DECISION OF THE QUEENSTOWN LAKES DISTRICT COUNCIL

Applicant: Brecon Street Partnership Limited

RM reference: RM180507

Location: 34 Brecon Street and Cemetery Road, Queenstown

4.1 BASEMENT PLAN

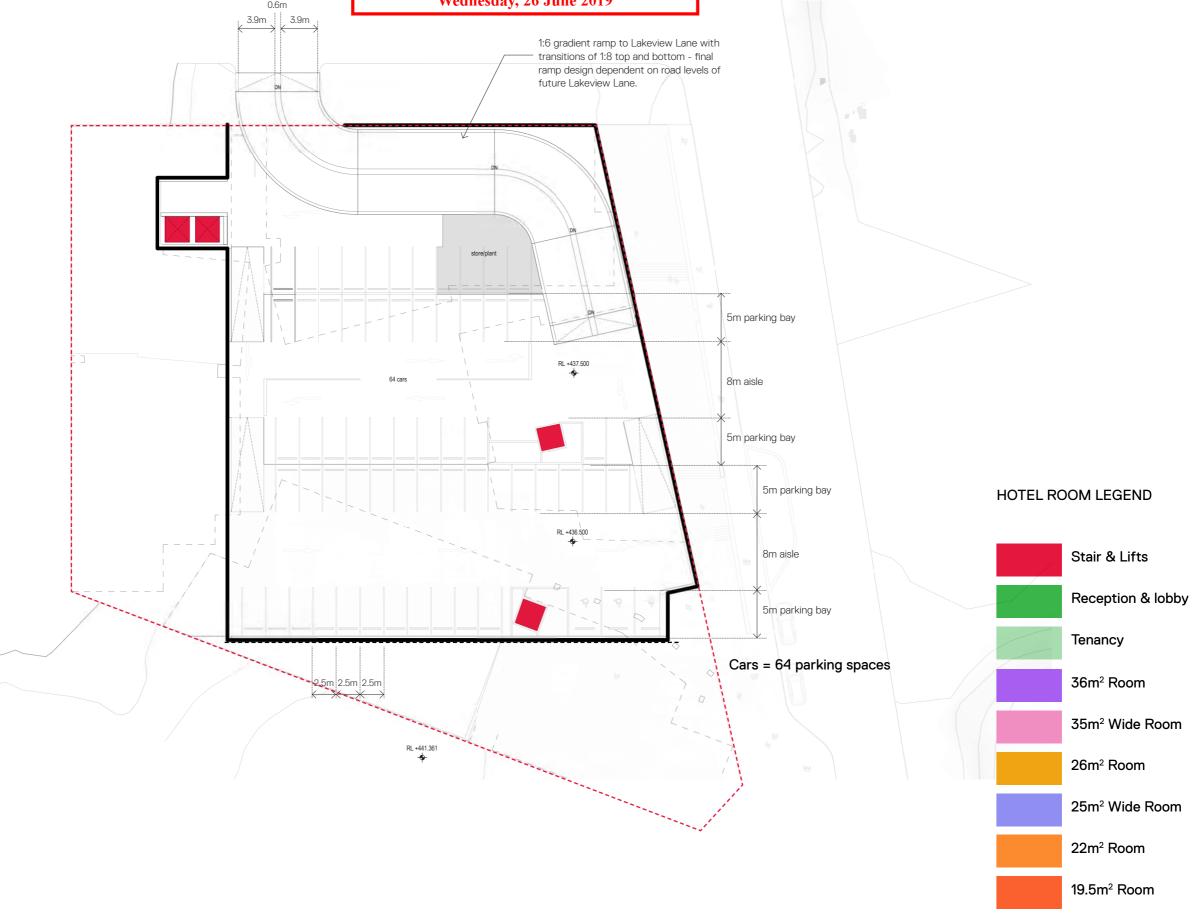
- Submit to Council's Manager of Resource Management Engineering for review and certification, a revised layout for basement parking access and manoeuvring to provide safe access for unfamiliar public users to the basement parking area. The revised layout shall demonstrate compliance with the relevant District Plan standards and shall include the required number of disabled parking spaces.

- 53. In the event that the basement parking area and access ramp are not redesigned to meet District Plan standards as part of Condition (6), a covenant pursuant to Section 108(2)(d) of the Resource Management Act 1991 shall be registered on the Computer Freehold Register of the subject site prior to operation of the hotel providing for the ongoing requirements below. The final wording of the instrument shall be checked and approved by the Council's solicitors at the consent holder's expense prior to registration to ensure that all of the Council's interests and liabilities are adequately protected.
 - Access to the basement parking areas shall be restricted at all times to 'valet' parking staff only. This includes the prevention of other hotel and retail staff using the basement parking areas.

Figure 4: Proposed public road and parking configuration

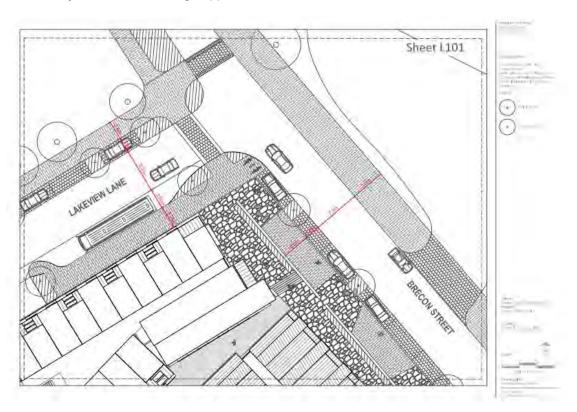
The location of the road and concept design generally reflects Figure E34 for a *Mixed Use Town Centre* location except that the proposed carriageway and footpaths are slightly wider that the COP and the gradient is shown, in some preliminary designs, as up to 12% longitudinal gradient. The road will service the proposed hotel, the existing Lakeview Holiday Park, and provide access to parts of the Lakeview development site and this road design figure is appropriate, in my opinion. The concept designs have been reviewed as appropriate in part by CCL and Stantec however there were insufficient details available to permit both experts to conclude assessment. For example a number of design options were presented in the application regarding the longitudinal gradient of Lakeview however these were not able to be wholly assessed by the expert transport engineers in regard to safe inter-visibility at the intersection of Cemetery Lane by all road users. The gradient may need marginally lessened to increase inter-visibility from the intersection and following engineering review I am satisfied this can be achieved subject to detailed design, including the resolution of any remaining expert concerns. I recommended related conditions of consent.

In summary I recommend conditions of consent requiring the formation of Lakeview Lane in compliance with Figure E34 of the QLDC Land Development and Subdivision Code of Practice. This requires a Movement lane of 6.5m with indented parking along both sides and 2.5m minimum width footpaths along both sides, all extending from Brecon Street approximately 85m in length and terminating at the western side of the Cemetery Road/Lakeview Lane new intersection. I recommend maximum road batters of 1V:5H to ensure maintenance of the road reserve aligns with Council expectations and/or retaining as approved by Council engineers. All intersections shall be designed in accordance with the latest Austroad standards, including the provision of expert transport evidence demonstrating safe inter-visibility and this includes providing appropriate road gradients and retaining solutions.

- j) The formation of a sealed public road (referenced Lakeview Lane by application) along the north-western side of the development site in accordance with Table 3.2 Figure E34 of the QLDC's Land Development and Subdivision Code of Practice. Specifically this shall include, but not limited to:
